PLANT NAME: DUANE ARNOLD
jcm 09/06/77

ENCLOSURE License No. DPR-49 Appl for Amend:
tech specs proposed change concerning on-site
emergency power systems.

August 30, 1977
IE-77-1624

PROPOSED CHANGE RTS-95 TO DAEC TECHNICAL SPECIFICATIONS

FIGURE 1 DAEC ESSENTIAL ELECTRICAL SYSTEM

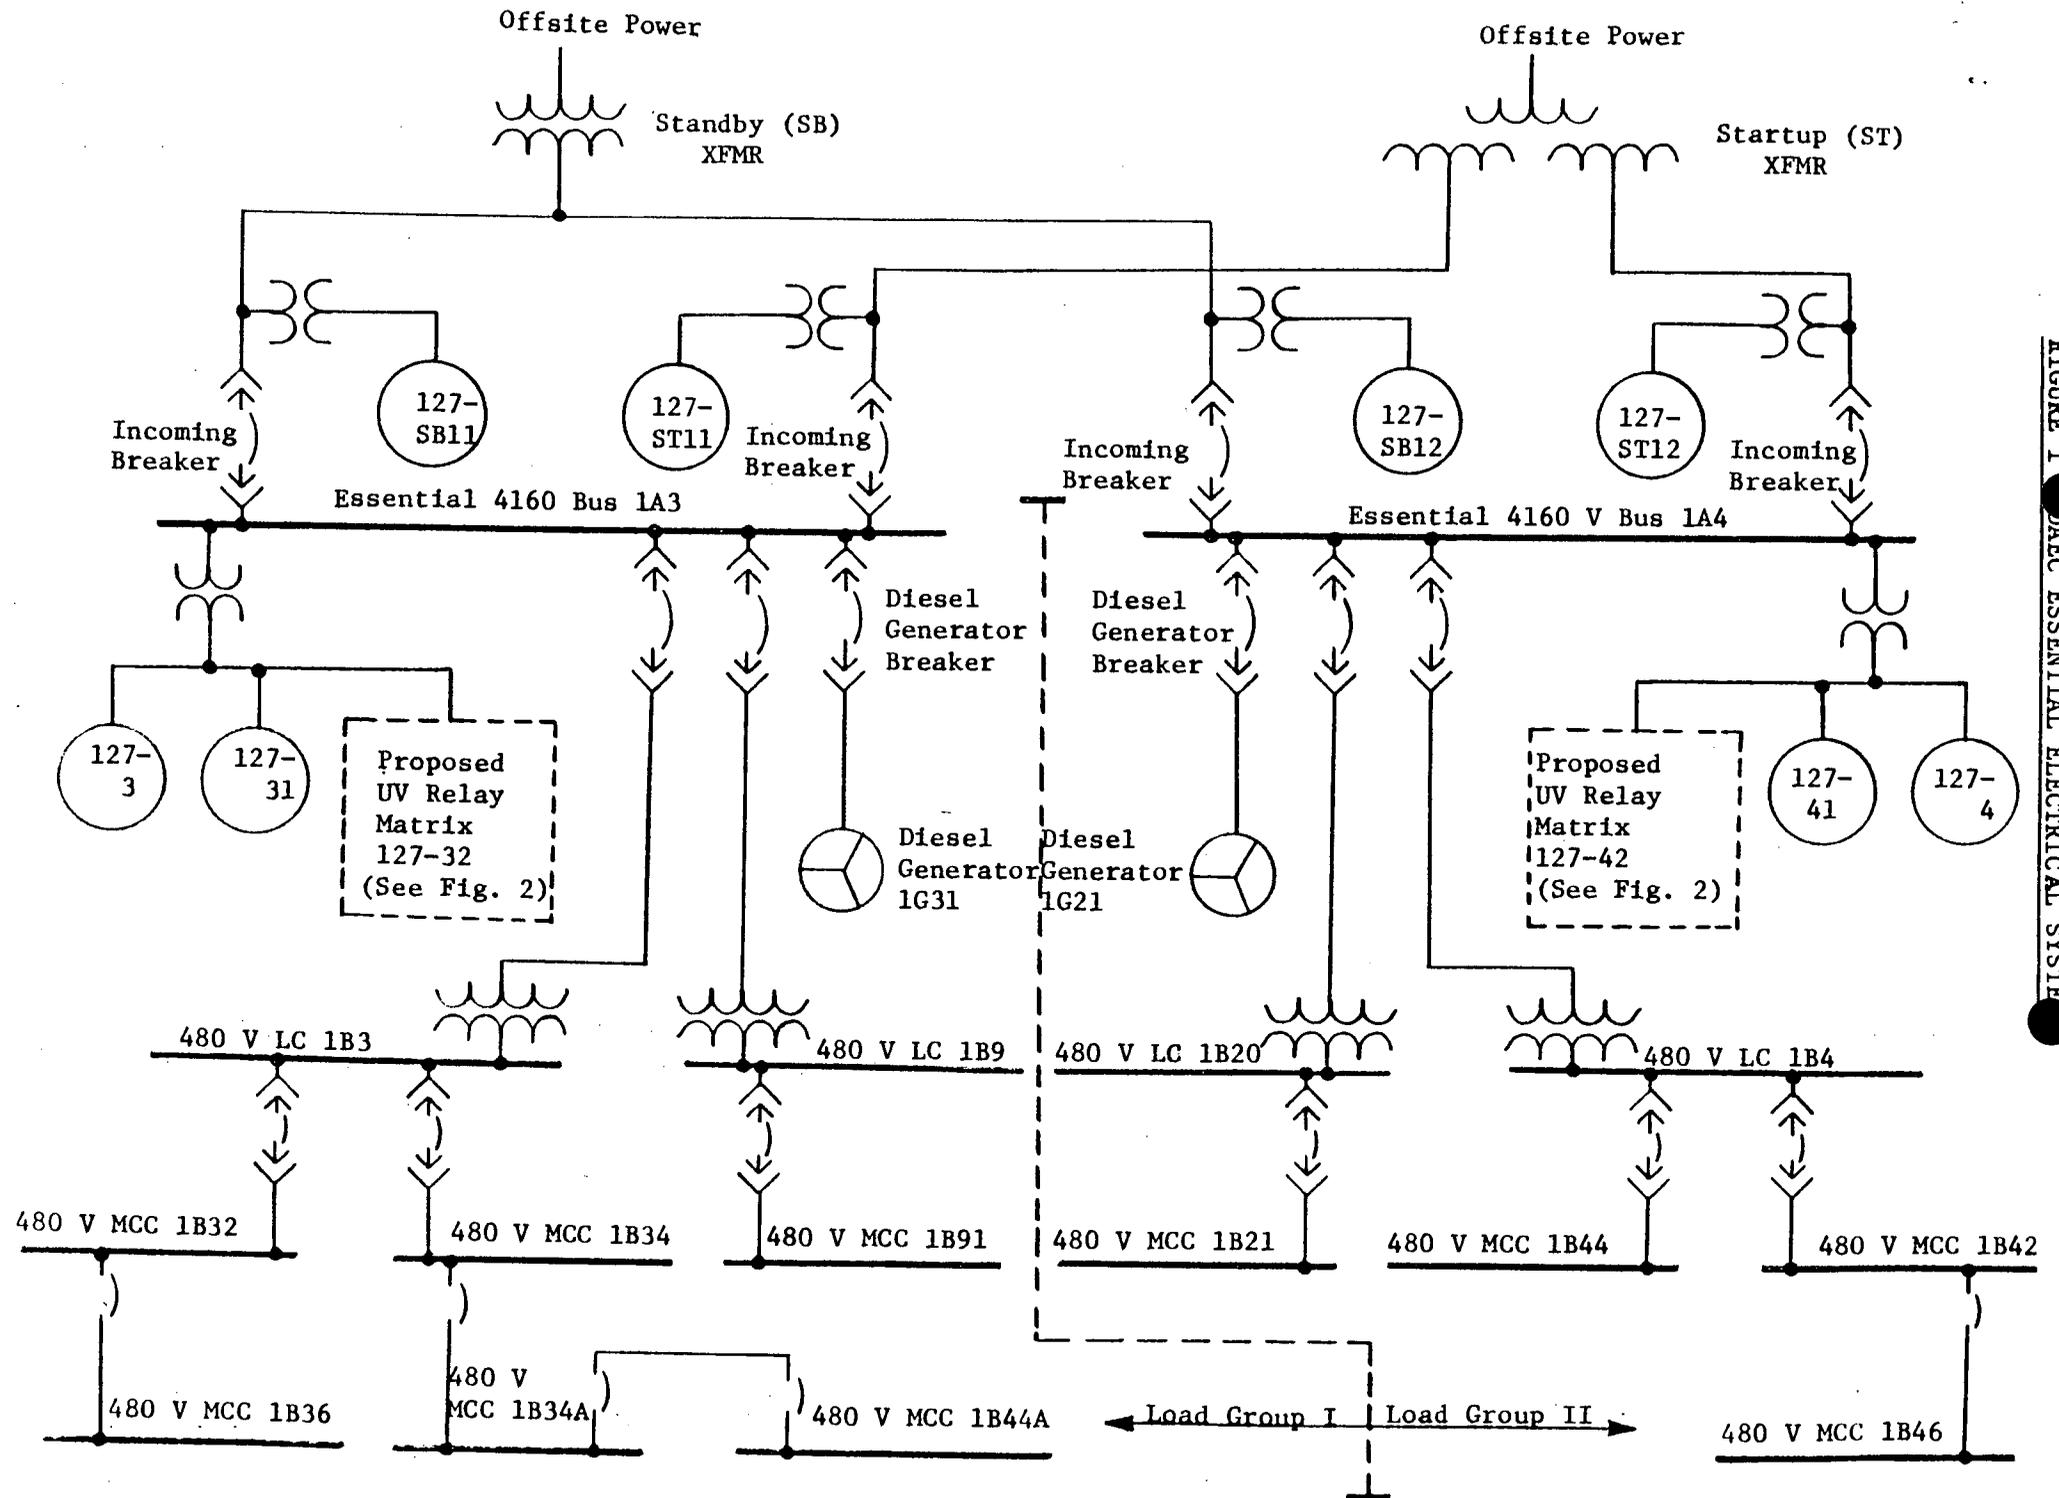
According to the voltage profile tables sent with our response of October 19, 1976 to your generic questions of August 11, 1976, essential motor control centers 1B36 and 1B46 consistently maintain the lowest voltage levels and may be considered the worst case. The voltage calculations made to prepare our previous response show that 86 percent of nominal voltage at MCC's 1B36 and 1B46 corresponds to a voltage level of 92.2 percent at 4.16 kV essential buses 1A3 and 1A4. We propose to establish the second level of undervoltage protection at 92.2 percent of nominal voltage on buses 1A3 and 1A4 by installing four additional single phase undervoltage relays to each of the essential 4.16 kV buses. Refer to Figure 1.

Each of the undervoltage relays will include an integral timer set to actuate 8.5 seconds after drop out of the undervoltage relay. This proposed time delay will not be added to the time delay stated in the FSAR for transfer to onsite emergency power upon a loss of offsite power (LOOP) or upon a LOOP coincident with a loss of coolant accident (LOCA). The time delay will preclude short duration disturbances from reducing the availability of the offsite power sources. A degraded voltage condition of 8.5 seconds duration will not result in the failure of any safety related equipment.

The proposed undervoltage relays will work in parallel with existing relays to monitor the essential bus voltages. If the essential 4160 V buses are being fed by offsite power, degraded bus voltages below 92.2 percent of nominal for 8.5 seconds will actuate the proposed coincidence logic. This will cause the bus incoming breakers to trip and the diesel generators to start. Due to the consequent total decay of the bus voltage, existing bus undervoltage relays (set at 20 percent of nominal bus voltage) will initiate a loss of offsite power (LOOP) load shed and prepare the safety related loads for energization by the diesel generators. When the diesel generator output voltage reaches 80.8 percent of nominal 4160 V bus voltage, existing relays will close the diesel generator breakers. Power available signals will then be sent to the sequencer logic.
